# Access Compliance Report

## Public Rights-of-Way

### (Curb Ramps)

Intersection ID: 48147	Main Street: MCCAMEY_DR	Cross Street: FRANKLIN_MEADOWS_DR	Location: SE
ADA ID: E7603FC8BA7E	Ramp Type: Perp	Initial Pass/Fail: Fail	Overall Compliance: No
			Severity Score: 21.25

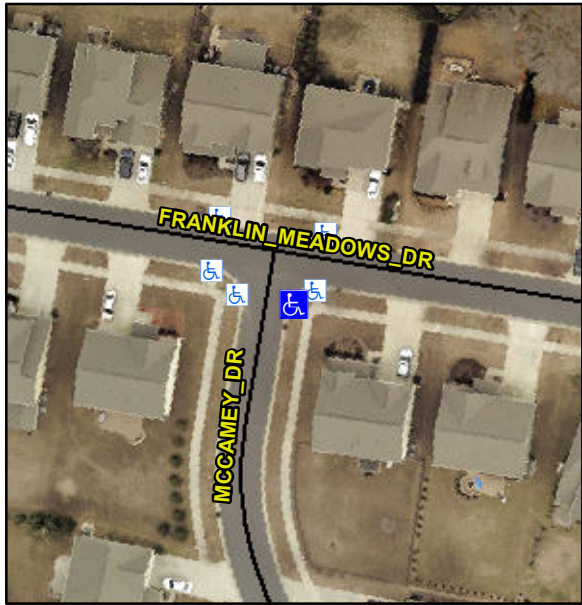
Codes/Mitigation Info/Possible Solution			Field Measurements/Component Compliance					
	Possible Solutions:		Compliance	Description	Data	Compliance	Description	Data
	Remove & Replace Entire Ramp.		N/A	Ramp Length (in)	98.0	No	Ramp Slope (%)	9.0
			No	Ramp Width (in)	47.0	Yes	Ramp XSlope (%)	0.1
			N/A	Flare Type LT	N/A	N/A	Flare Type RT	N/A
			N/A	Flare Slope LT (%)	N/A	N/A	Flare Slope RT (%)	N/A
			N/A	Flare Traversable LT?	N/A	N/A	Flare Traversable RT?	N/A
			N/A	Landing Length (in)	N/A	N/A	DWS Provided?	N/A
			N/A	Landing Width (in)	N/A	N/A	DWS Contrast?	N/A
			N/A	Landing Slope (%)	N/A	N/A	DWS Length (in)	N/A
			N/A	Landing X Slope (%)	N/A	N/A	DWS Full Width?	N/A
Surveyor Notes:		N/A	N/A	Landing Curb? (Y/N)	N/A	N/A	DWS Offset (in)	N/A
PROW/ADA:		Not Found, R304.5.1, R304.2.2	N/A	Shared Landing?	N/A	N/A	Gutter Slope (%)	N/A
			N/A	Gutter Ponding?	N/A	N/A	Gutter X Slope (%)	N/A
			N/A	Gutter Lip Ht (in)	N/A	N/A	Painted X Walk2?	N/A

N/A	Painted X Walk1?	No	N/A	X Walk 2 Direction	N/A
				X Walk 1 Direction	To W		X Walk 2 Width (in)	N/A
			N/A	X Walk 1 Width (in)	N/A	N/A	X Walk 2 Slope (%)	N/A
				X Walk 1 Slope (%)	1.5		X Walk 2 X Slope (%)	N/A
				X Walk 1 X Slope (%)	1.6		Ramp inside XWalk2?	N/A
			N/A	Ramp inside XWalk1?	N/A	N/A	Clear Space?	N/A
				Road Slope (%)	N/A	N/A	Clear Space to XWalk (in)	N/A
				Road X Slope (%)	N/A	N/A	Storm Grate/Utility Hazard?	N/A
			N/A	Any Obstructions?	N/A	N/A	Storm Grate/Utility Type	N/A
				Obstruction Type				
					N/A			N/A
						Yes	Surface Condition? (G/P)	Good
